SERVICE BULLETIN

N° 139-685

ATA 93 - AIRCRAFT SURVIVABILITY EQUIPMENT (ASE) MODIFICATION

This Service Bulletin is issued in order to provide the necessary instruction on how to perform the FLIR variant for kit ASE P/N 3G5311A59011 and the ASE complete provision P/N 3G9350A08112.

Figure 1

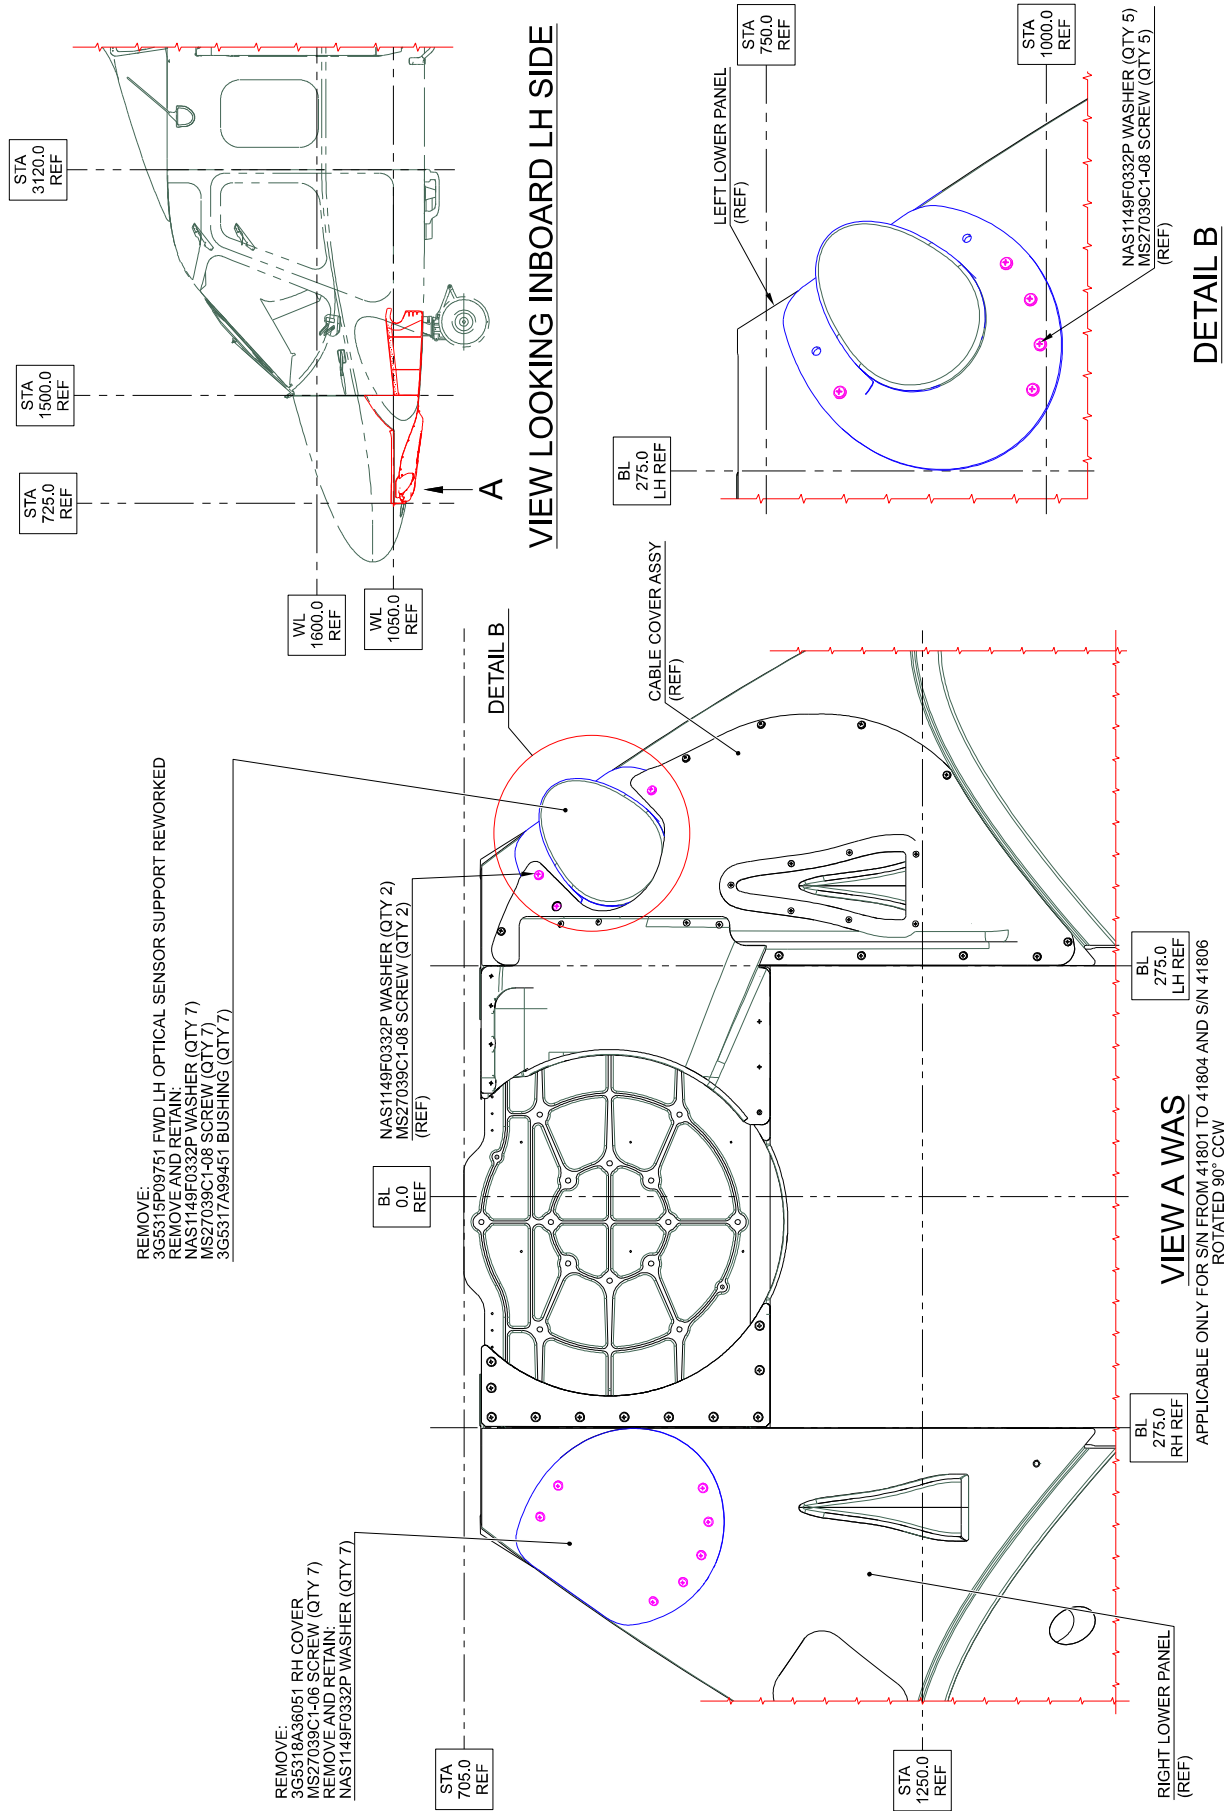
- 6.1 In accordance with AMP DM 39-A-08-21-00-00A-028A-A, level the helicopter.
 - 6.2 With reference to Figure 1 View A Was, remove the RH cover P/N 3G5318A36051, n°7 screws P/N MS27039C1-06 and n°7 washers P/N NAS1149F0332P from the right lower panel. Retain washers for later reuse.

- 6.3 With reference to Figure 1 View A Was and Detail B, remove the FWD LH optical sensor support reworked P/N 3G5315P09751, n°7 screws P/N MS27039C1-08, n°7 bushings P/N 3G5317A99451 and n°7 washers P/N NAS1149F0332P from the left lower panel P/N 3P5331A54331. Retain hardware for later reuse.

Figure 2

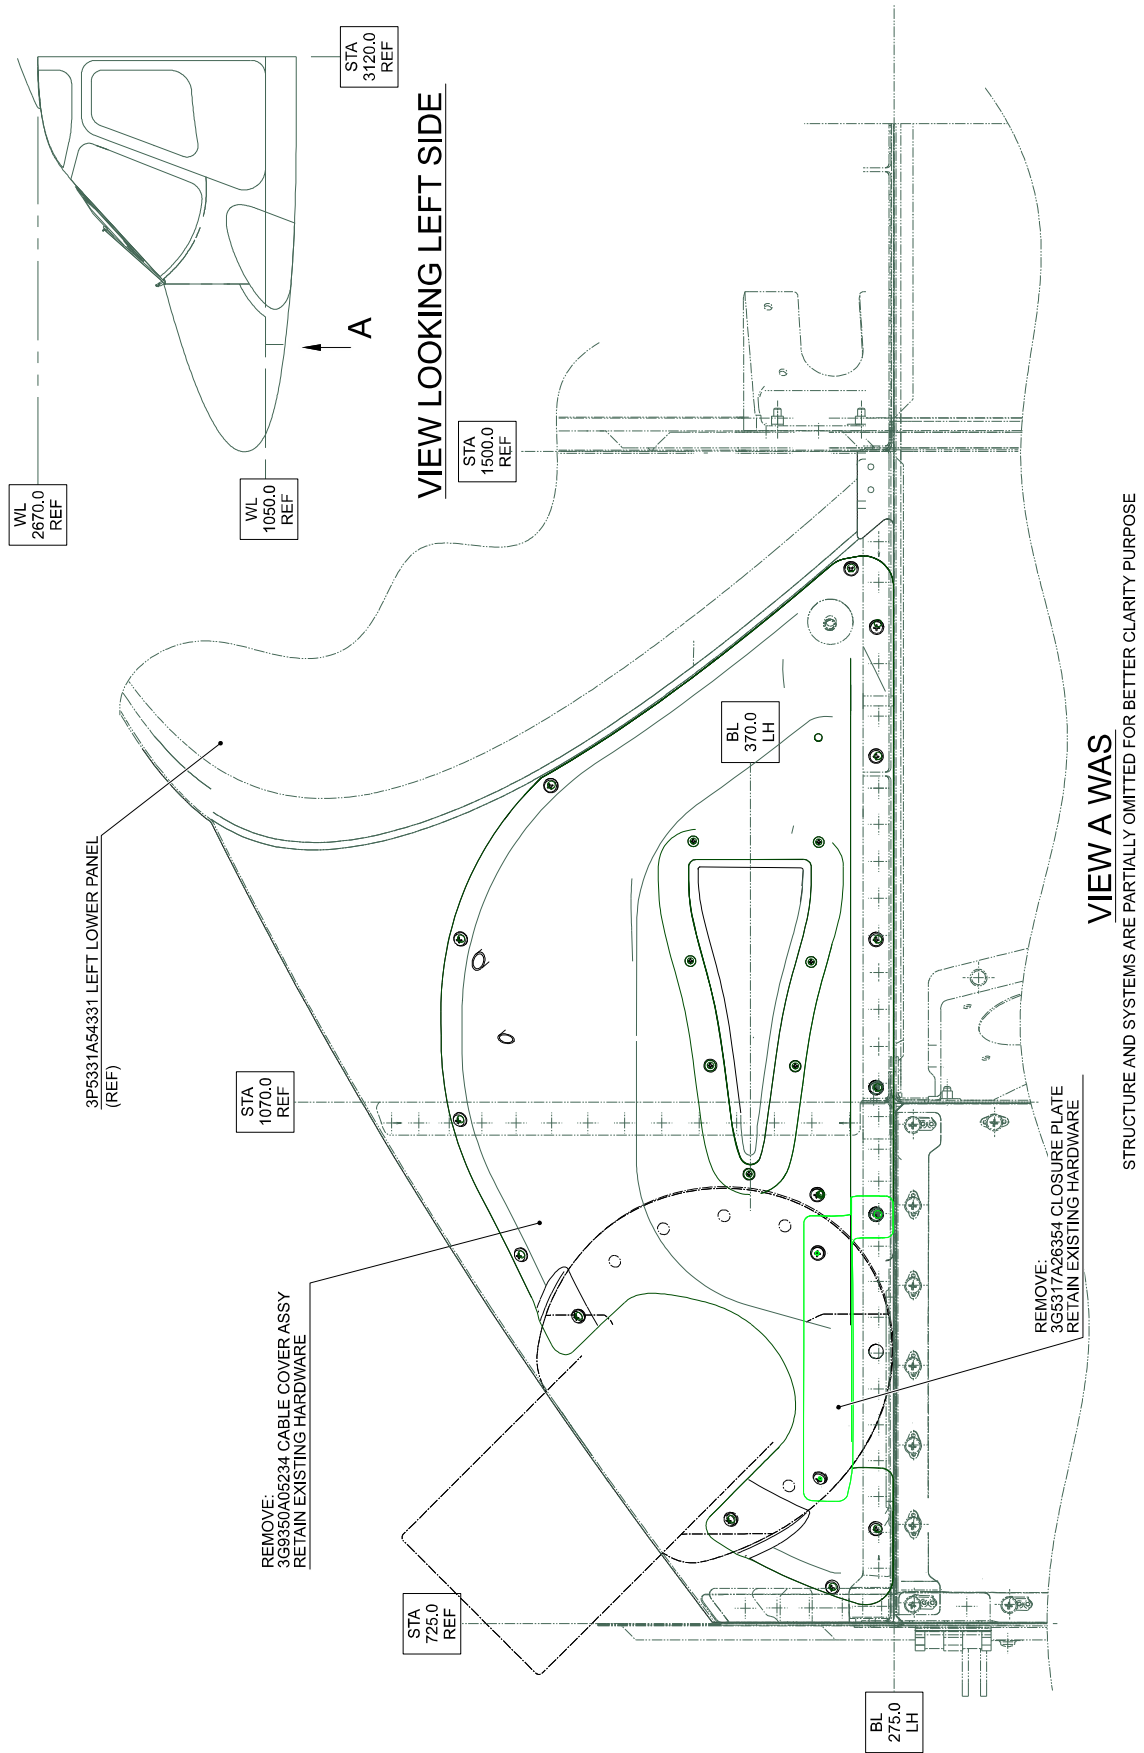
3. With reference to Figure 7 View A, remove and retain for later reuse the left cover assy for FLIR P/N 3G5331A63735 and existing hardware.
 4. With reference to Figure 2 View A Was, remove and retain for later reuse the closure plate P/N 3G5317A26354 and existing hardware.

5. With reference to Figure 2 View A Was, remove and retain for later reuse the cable cover assy P/N 3G9350A05234 and existing hardware from the left lower panel P/N 3P5331A54331.

Figure 3

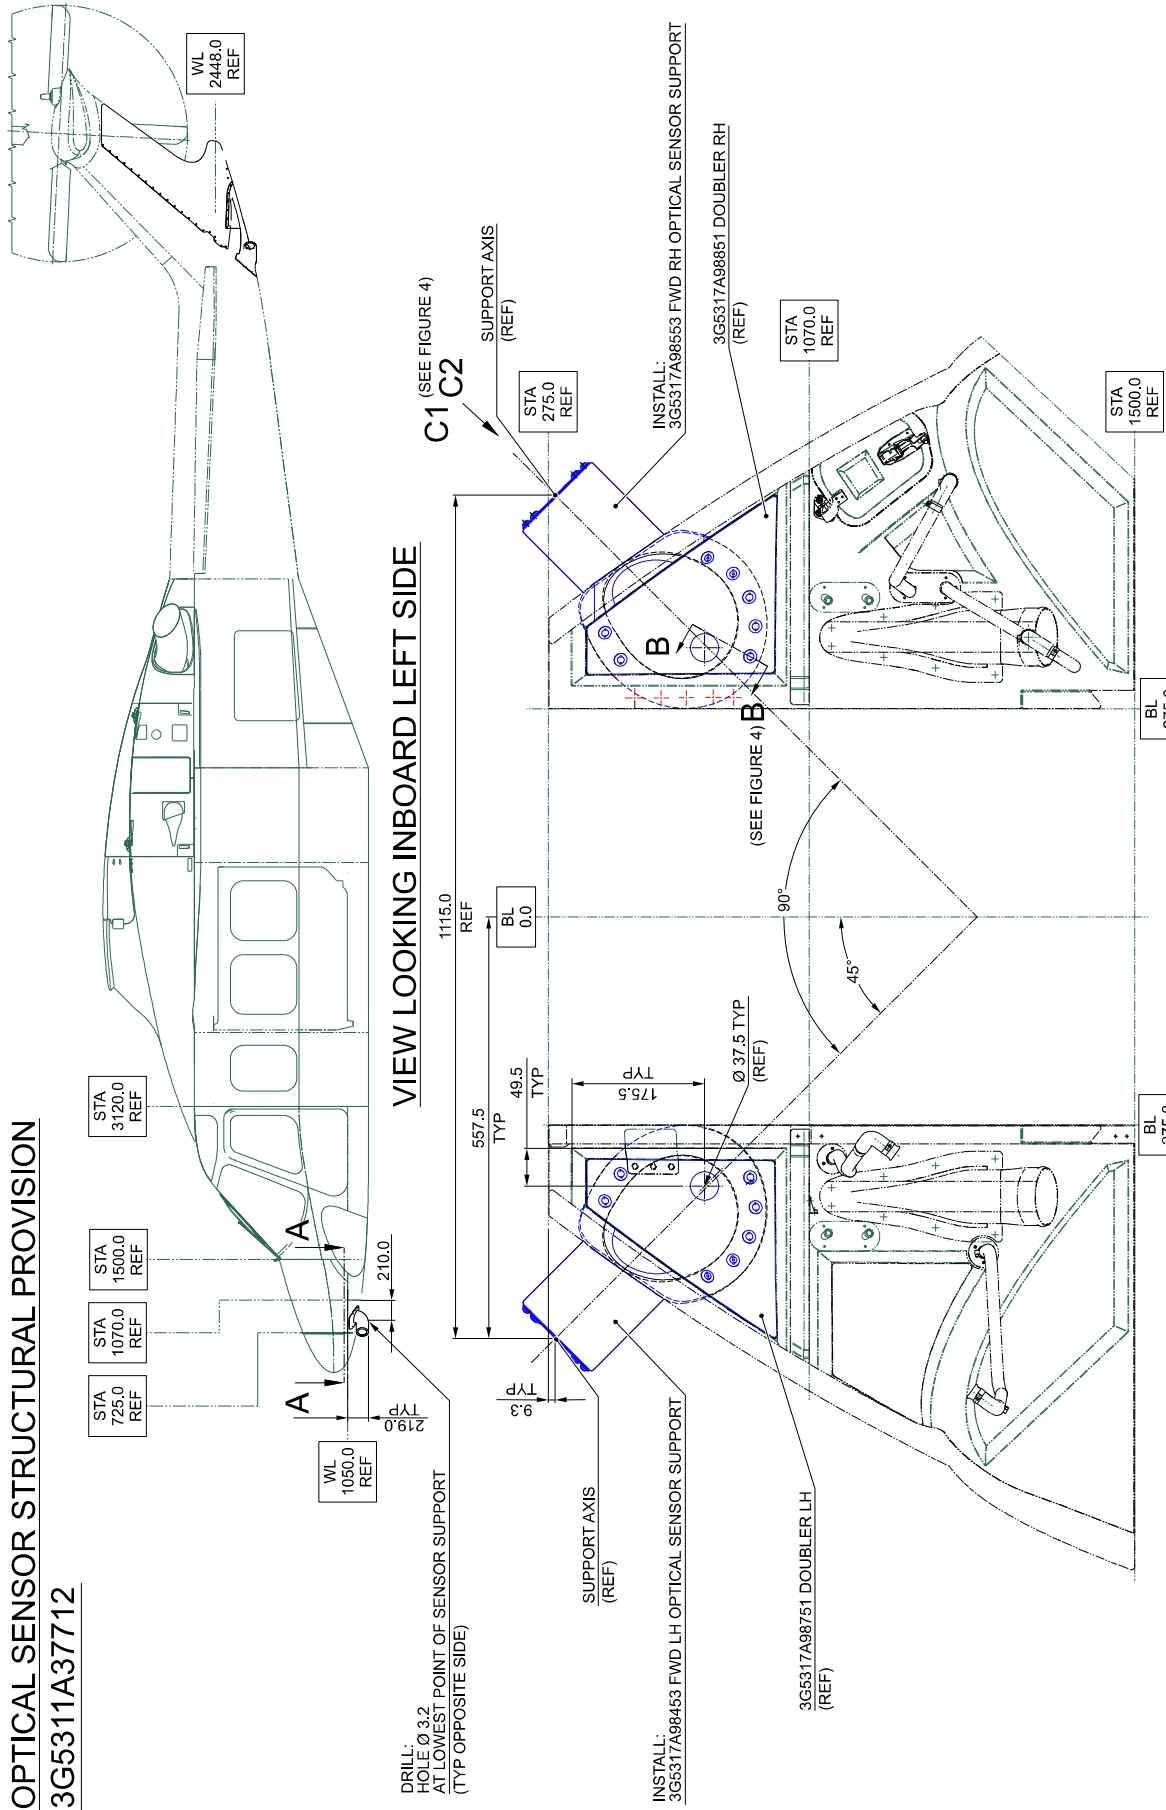
- 6.5 With reference to Figure 3 View A-A and Figure 4 Section B-B, temporarily locate the FWD RH optical sensor support P/N 3G5317A98553 on the right lower panel P/N 3G5331A38331 and install n°7 bushings P/N 3G5317A99451 by means of the adhesive C231.

- 6.7 With reference to Figure 3 View A-A and Figure 4 Section B-B, install the FWD RH optical sensor support P/N 3G5317A98553 on the right lower panel P/N 3G5331A38331 by means of n°7 screws P/N MS27039C1-08 and n°7 existing washers P/N NAS1149F0332P previously removed at step 6.1. Apply the sealant MC-780 (C465) on the contour.

- 6.8 With reference to Figure 3 View Looking Inboard Left Side, drill the hole Ø3.20 thru the lowest point of the FWD RH optical sensor support P/N 3G5317A98553 in accordance with the dimensions shown.

Figure 4

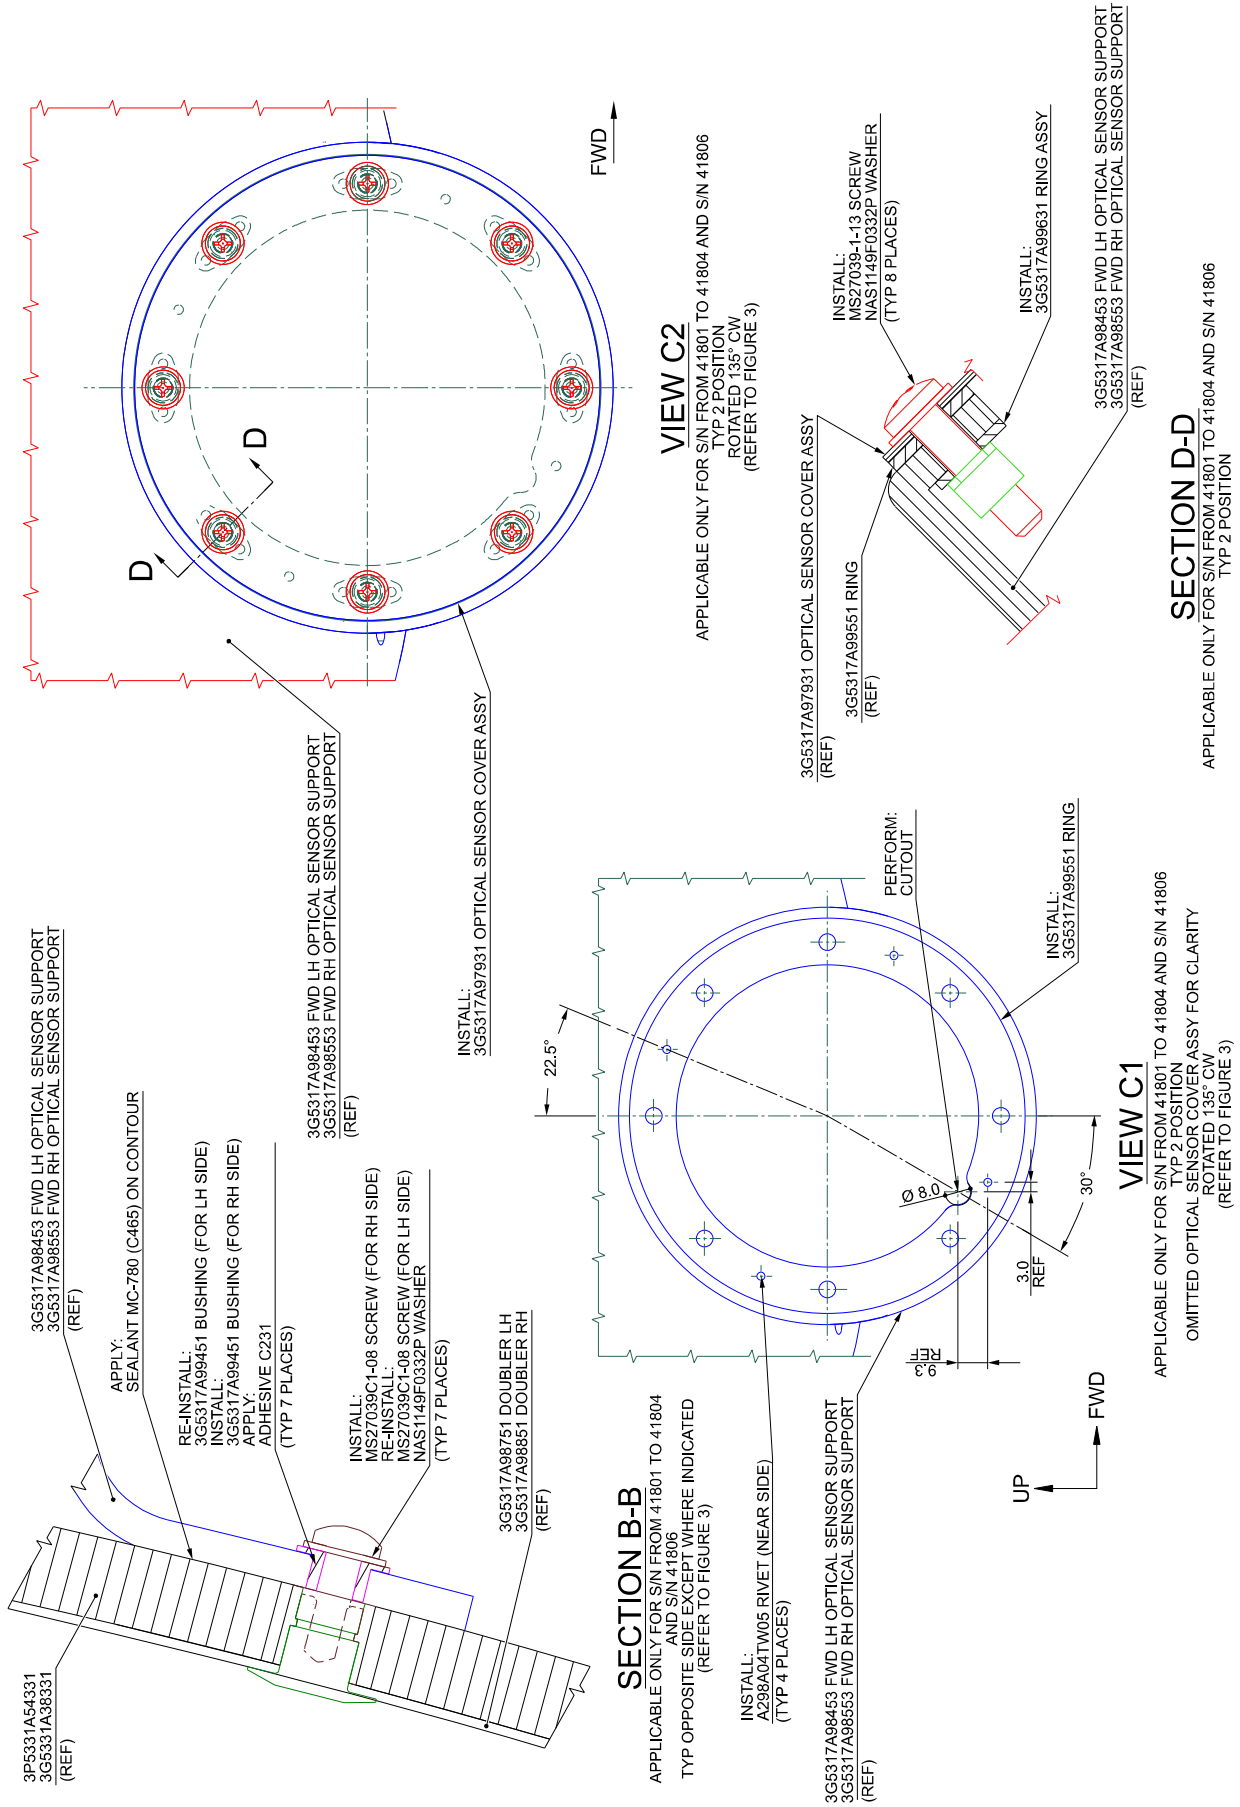
- 6.4 With reference to Figure 4 View C1, perform the indicated cut out on the ring P/N 3G5317A99551, on the ring assy P/N 3G5317A99631 and on the FWD optical supports P/N 3G5317A98453 (LH) and P/N 3G5317A98553 (RH).

- 6.6 With reference to Figure 4 View C1/C2 and Section D-D, install the ring P/N 3G5317A99551 and the ring assy P/N 3G5317A99631 by means of n°4 rivets P/N A298A04TW05. Install the optical sensor cover assy P/N 3G5317A97931 on the FWD RH optical sensor support P/N 3G5317A98553 by means of n°8 screws P/N MS27039-1-13 and n°8 washers P/N NAS1149F0332P.

Figure 5

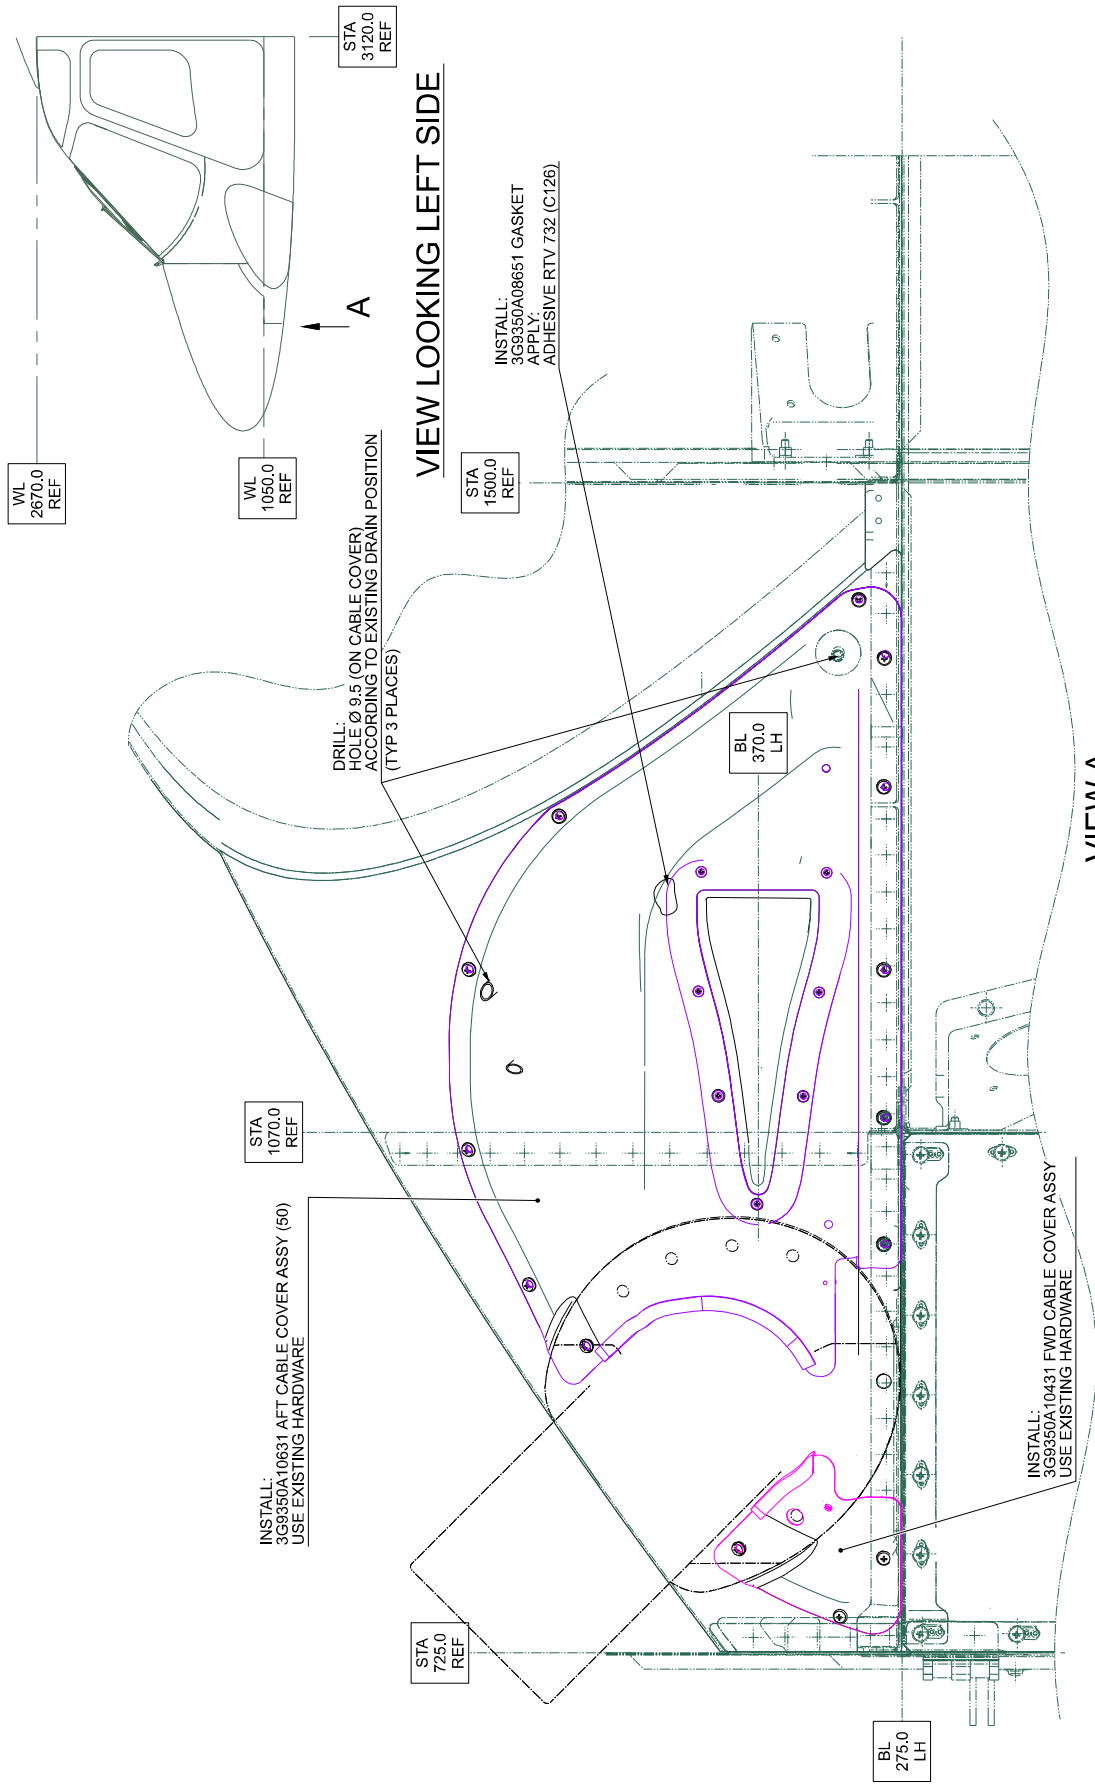
12. With reference to Figure 5, perform the FLIR 380HD structural variant for ASE P/N 3G5310P10112 as described in the following procedure:
 - 12.1 With reference to Figure 5 View A, temporarily locate the aft cable cover assy P/N 3G9350A10631 on the left lower panel P/N 3P5331A54331 and countermark n°3 holes in accordance with the existing drain positions.

- 12.2 With reference to Figure 5 View A, drill n°3 holes Ø9.50 thru the aft cable cover assy P/N 3G9350A10631.
 - 12.3 With reference to Figure 5 View A, install the gasket P/N 3G9350A08651 by means of the adhesive RTV 732 (C126).

- 12.4 With reference to Figure 5 View A, install the aft cable cover assy P/N 3G9350A10631 on the left lower panel P/N 3P5331A54331 and on the FWD LH optical sensor support P/N 3G5317A98453 by means of existing hardware previously removed at step 5.

- 12.5 With reference to Figure 5 View A, install the FWD cable cover assy P/N 3G9350A10431 on the left lower panel P/N 3P5331A54331 and on the FWD LH optical sensor support P/N 3G5317A98453 by means of existing hardware previously removed at step 5.
